Registry No. **W00166-W00169**

Sublocality **Hood Canal and Dabob Bay**

SUBJECT: Approval Memorandum for W00166-W00169
Hood Canal, Washington

SUBJECT: Review of Outside Source Data Surveys W00166-W00169
U.S. Naval Oceanographic Office (NAVOCEANO)
Puget Sound, Hood Canal and Dabob Bay

12.0 Smooth Sheet Production:

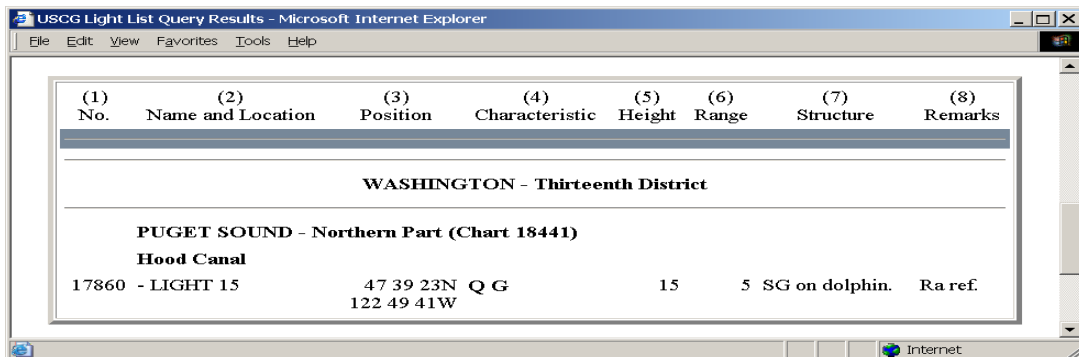
1. The side-scan contact file contains all of the relevant information needed, assuming that significant contacts which were developed and investigated further will appear on the smooth sheet with the appropriate symbol.

2. The following recommendation for Oak Head Light 15 Symbolization:

- to use " black circle with a small x inside (Carto Code 200)."
- 'Oak Head Light "15" (dol)'.

Recommendation is to add side-scan line/file name and image name to the contact spreadsheet, if a thumbnail image exists.
